Aftersales Bulletin

00 63 82 01 00 – Recall RR11 Headlight Replacement

USA - TECHNICAL CAMPAIGN (Non-Compliance Recall 22V-721) – Complete before vehicle handover

63 12 021 – Remove and install both headlights.

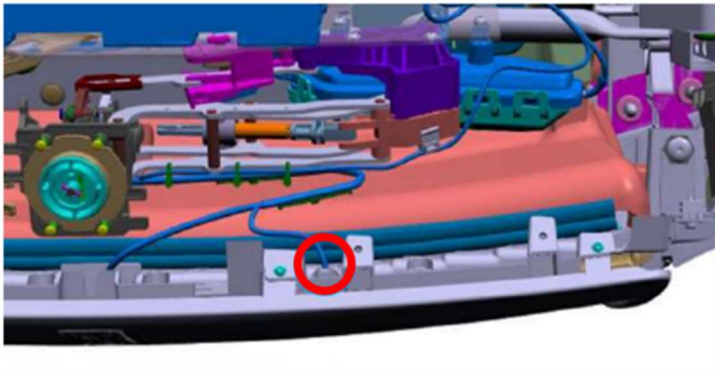
Please note the following additional points when removing the illuminated grill:

- Prior to removing the grill, the air guide fixings need to be removed.

- Disconnect plug connectors for grill illumination
